RE: Federal Cell Facility Application Request for Information

Federal Cell Application Review

Request for Information or Updates to the Application (RFI)

Appendix B: Federal Cell Facility Engineering Drawings

ENERGYSOLUTIONS
CLIVE FACILITY
FEDERAL WASTE CELL
EMBANKMENT FEATURES AND CONTROLS
CLIVE, UTAH

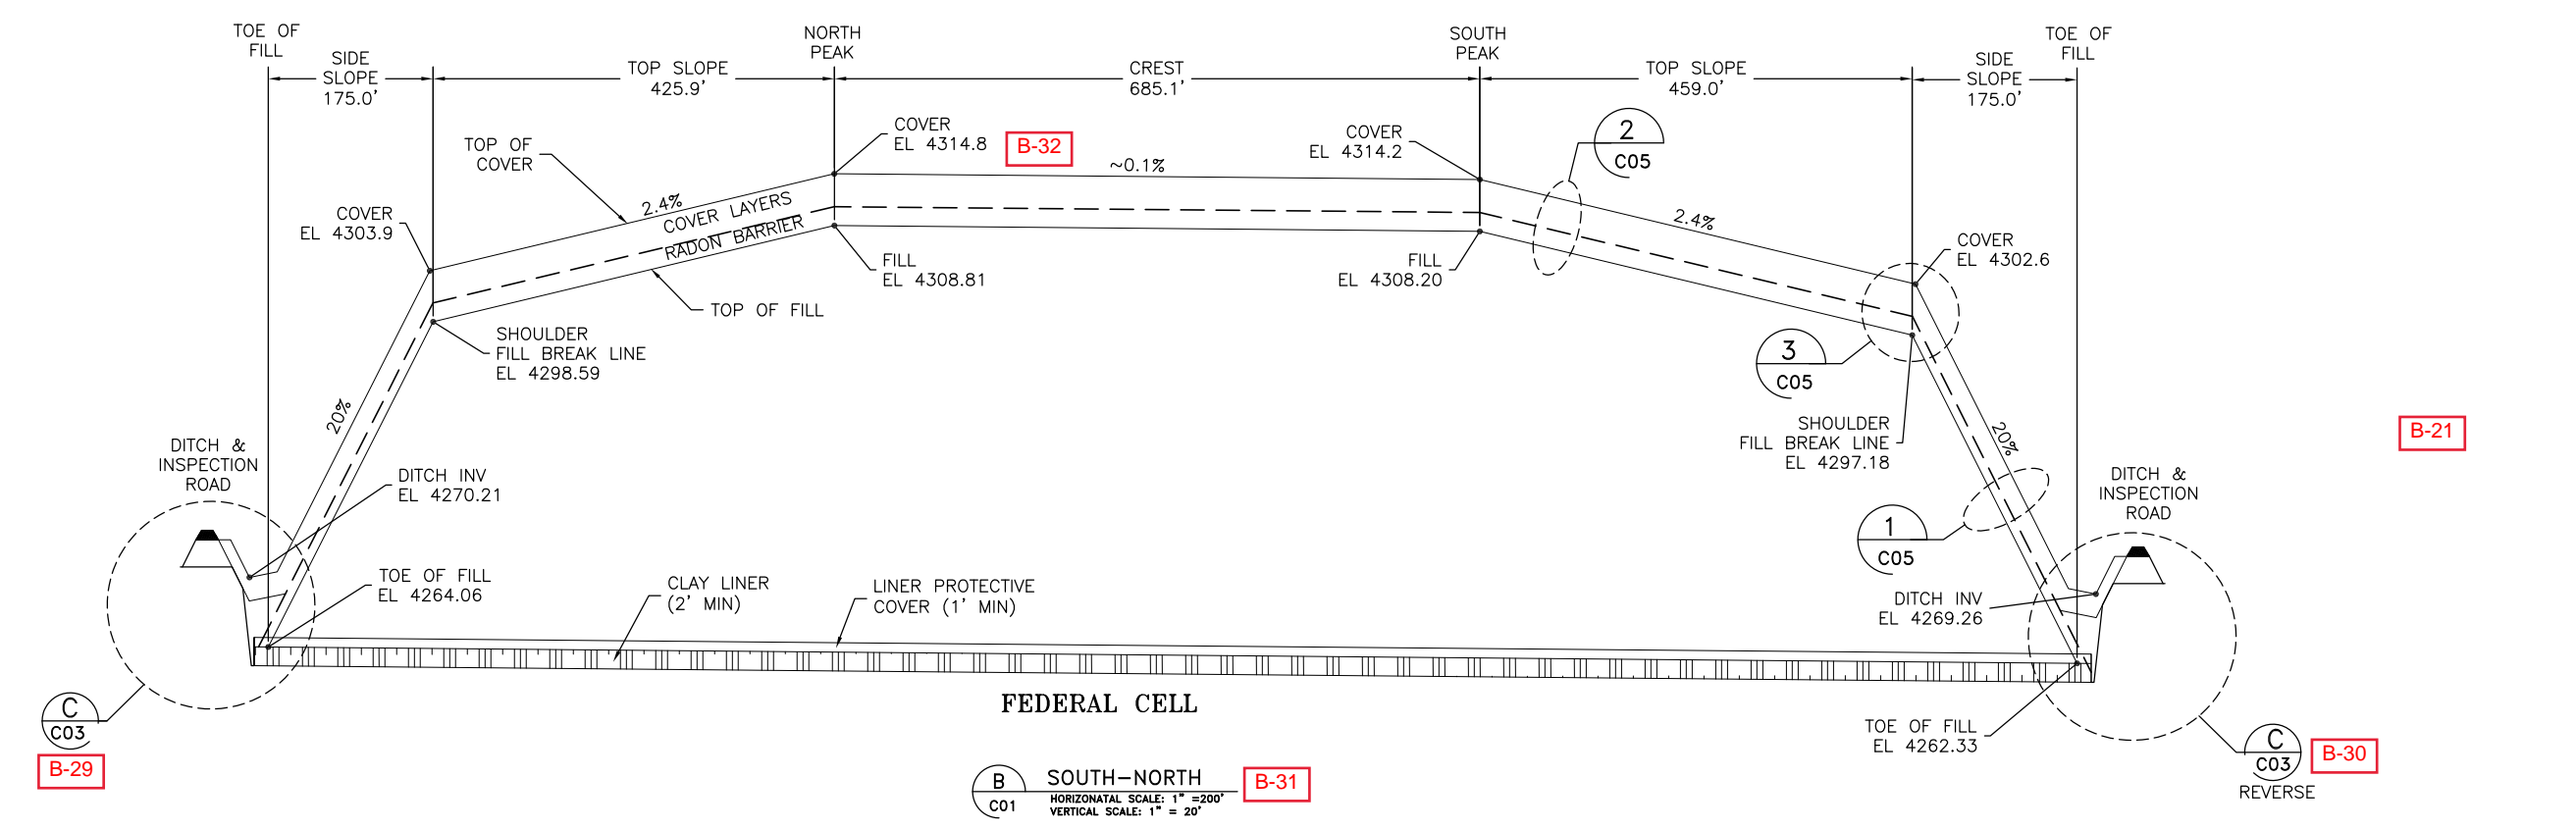
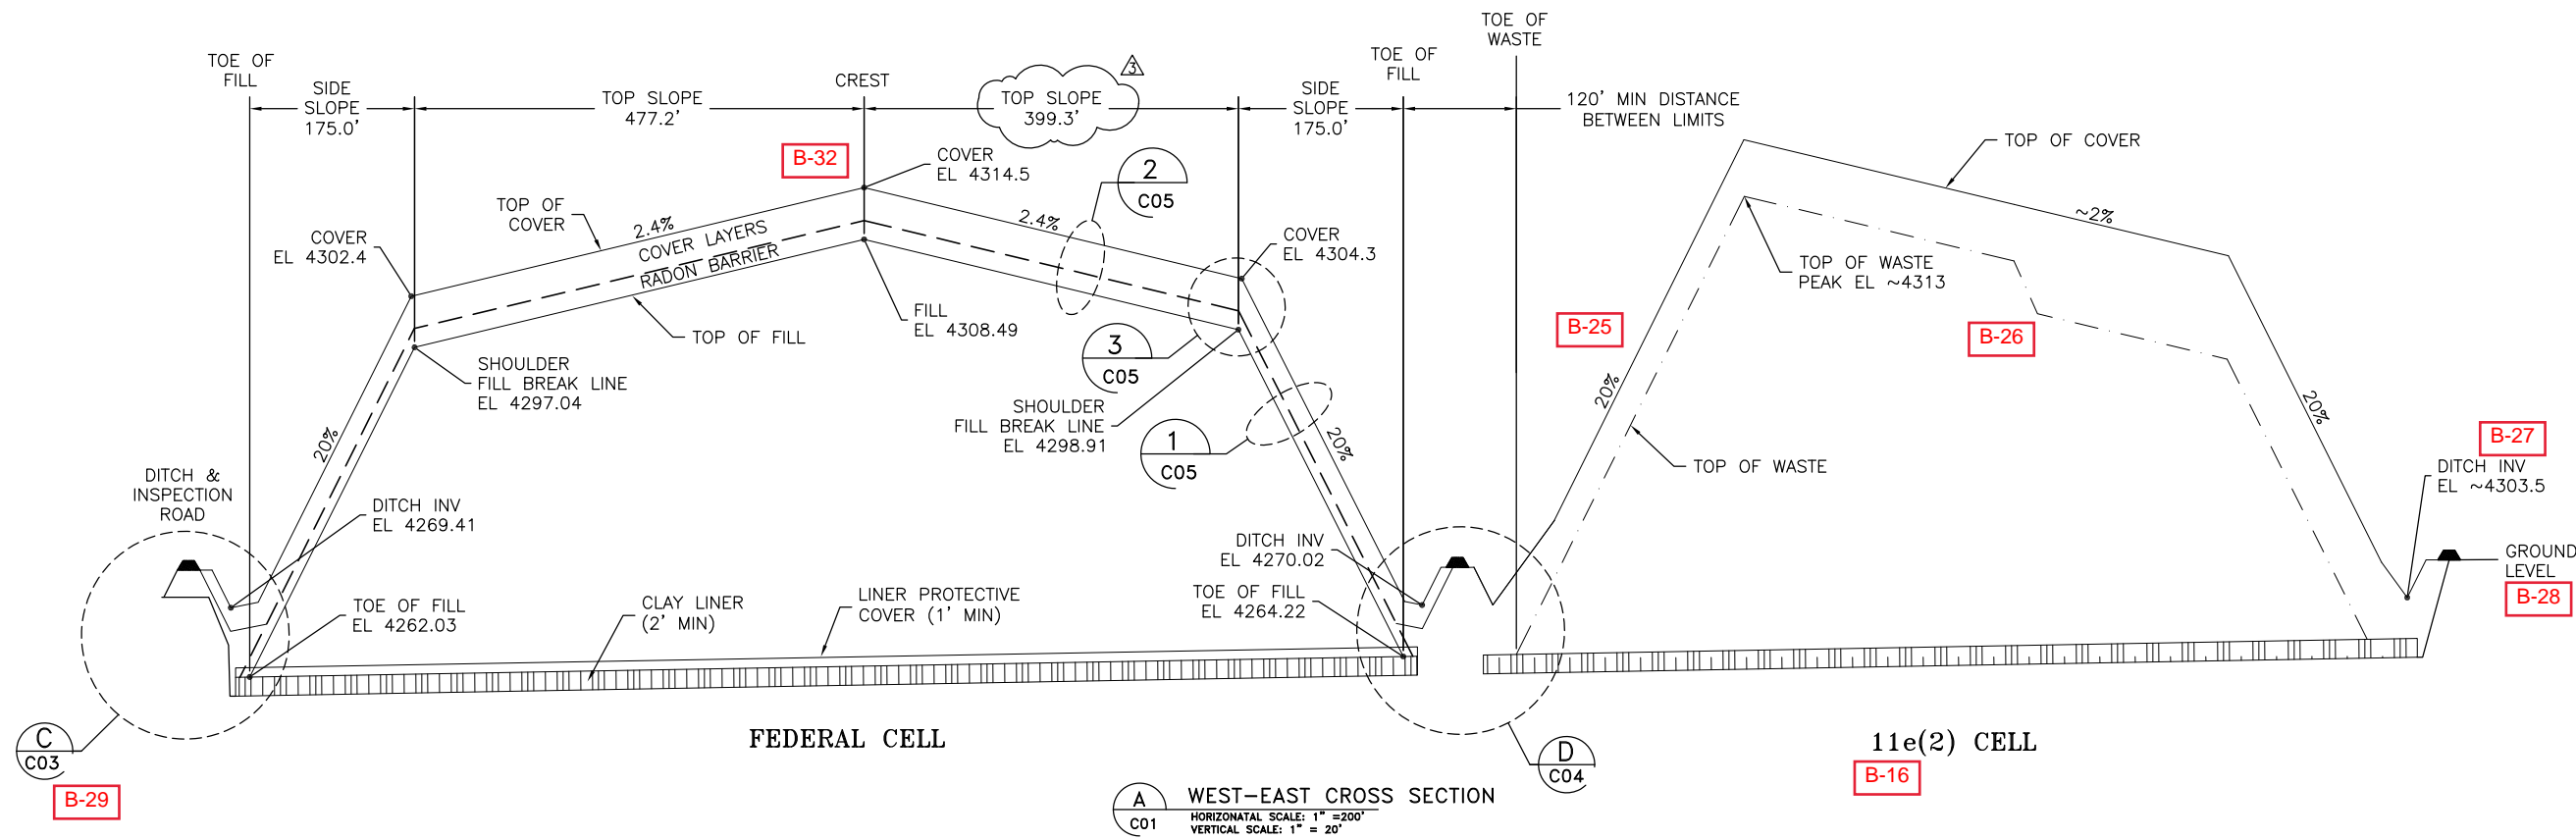
- **B-12**

- **B-13**

- **B-14**

- **B-15**

- **B-18**

- **B-19**

- **B-20**

- **B-22**

- **B-23**

ENERGYSOLUTIONS
 CLIVE FACILITY
 FEDERAL WASTE CELL
 EMBANKMENT CROSS SECTIONS
 CLIVE, UTAH

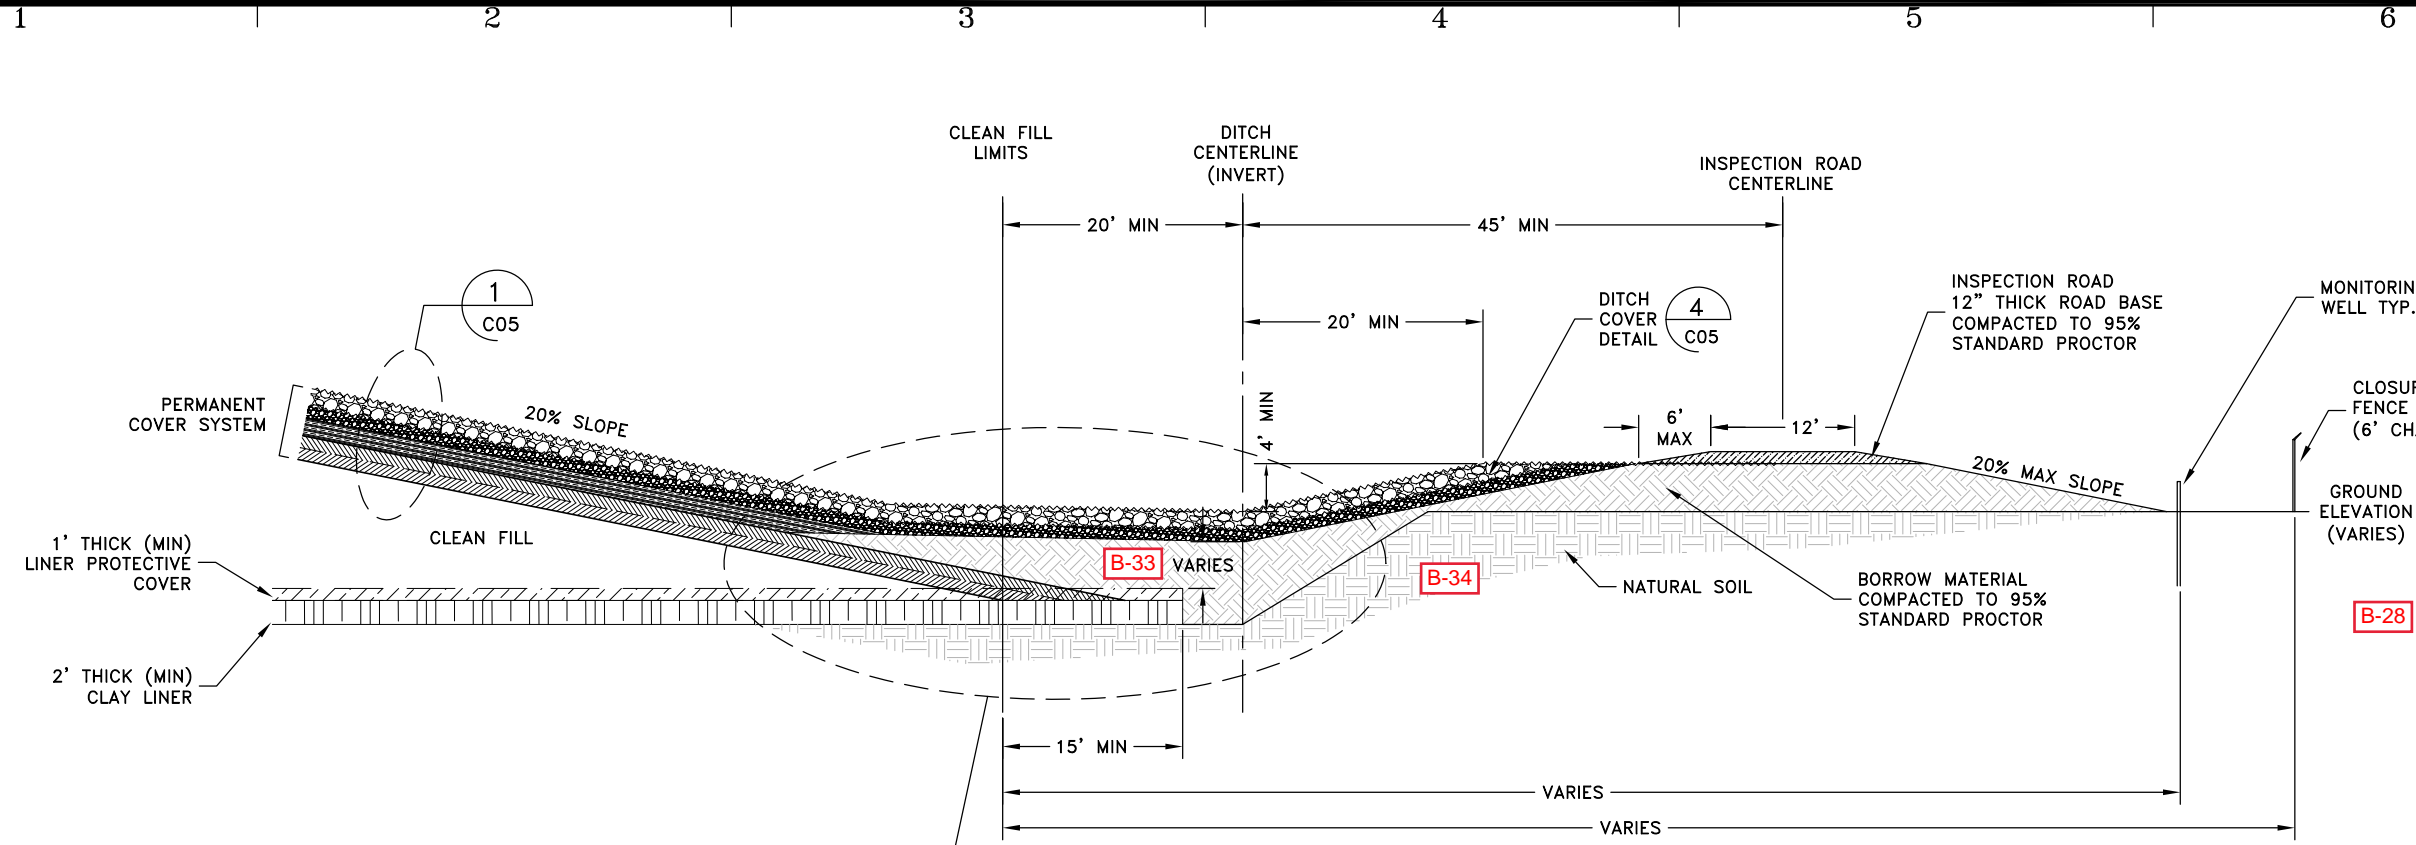
- **B-25**

- **B-26**

- **B-27**

- **B-28**

ENERGYSOLUTIONS
 ENERGY SOLUTIONS "CLIVE" FACILITY
 FEDERAL WASTE CELL
 SECTIONS AND DETAILS, 3 OF 3
 CLIVE, UTAH

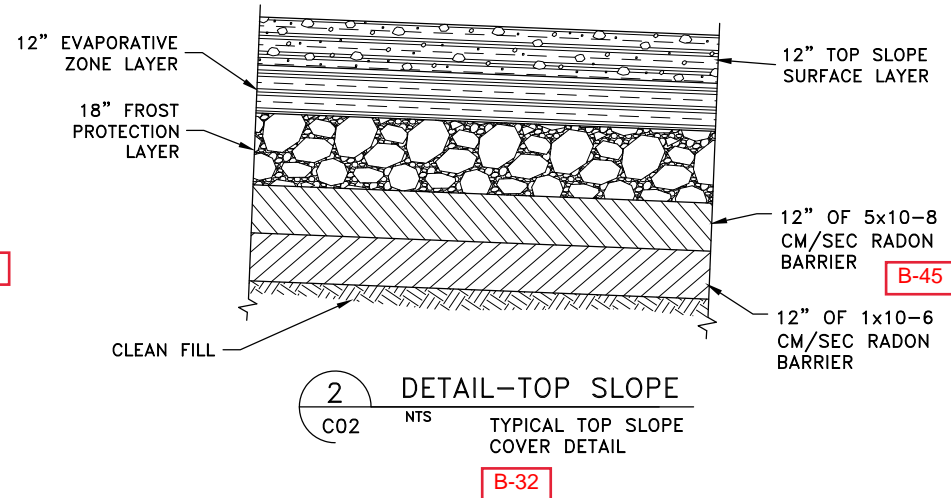
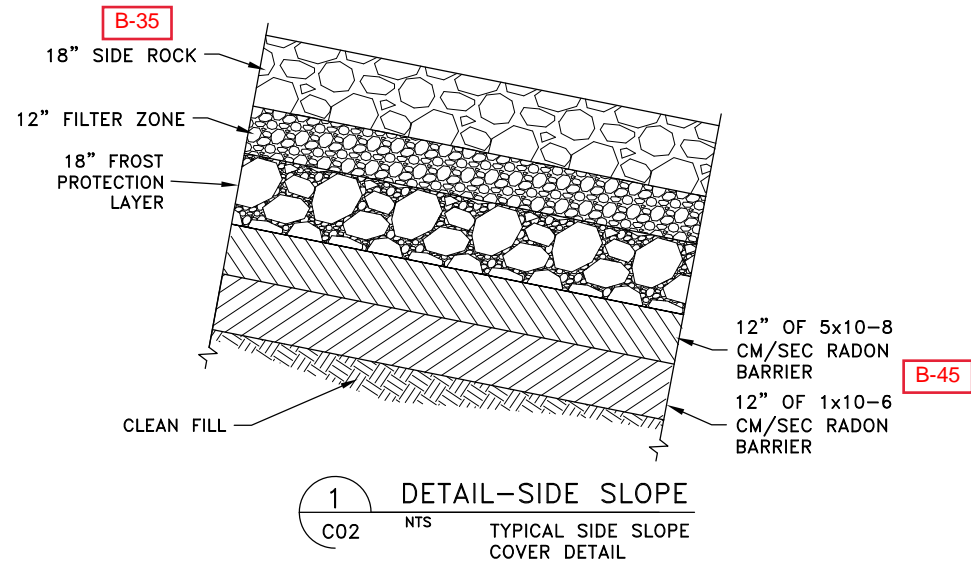
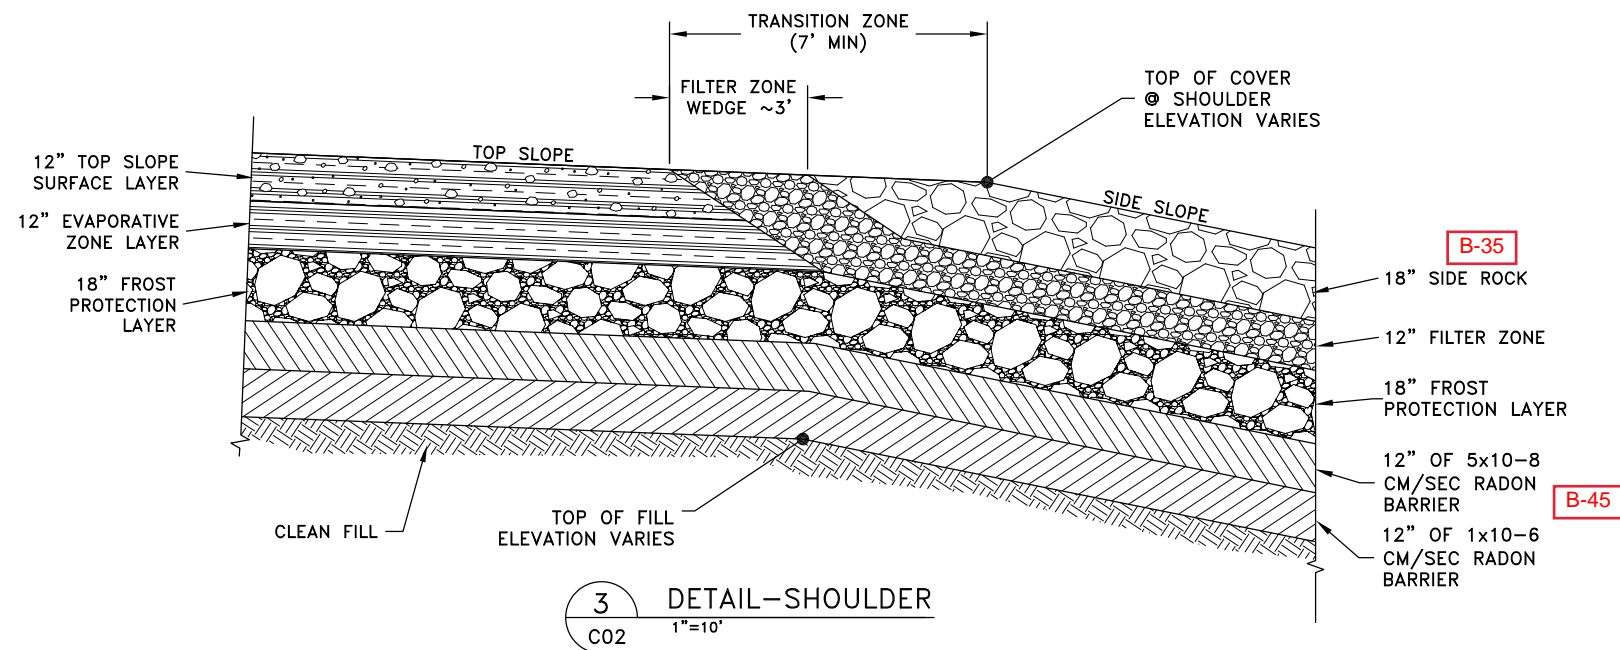
- **B-35**

- **B-46**
